### **Hexham rail roads submission SS1 - 4992**

10<sup>th</sup> September 2012

We wish to oppose the Hexham rail project and put forward the following reasons for our objection.

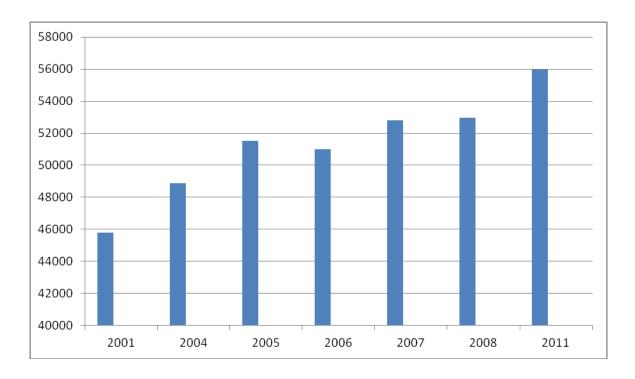
The existing traffic conditions and volumes also do not represent the current position.

Table 10.2d and e only show data up to 2008. That is four years ago.

The following table shows the position with the inclusion of the 2011 traffic volume of 55482 at count station 05.055.

Based on the construction traffic volumes 380 trips per day in table 10.3a the ADT would rise substantially to 56328.

By description in the EIS most of the extra 380 trips would be heavy and very heavy vehicles.

With a major section of roadway at choke point this additional traffic will have a critical impact.

A condition of consent for the project should prohibit site traffic from entering or leaving the site between the hours of 6:30am and 9:30am

from 3:30pm and 6:30 pm weekdays. To compromise Sunday, Public Holiday and up to 10pm weekdays work should be permitted.
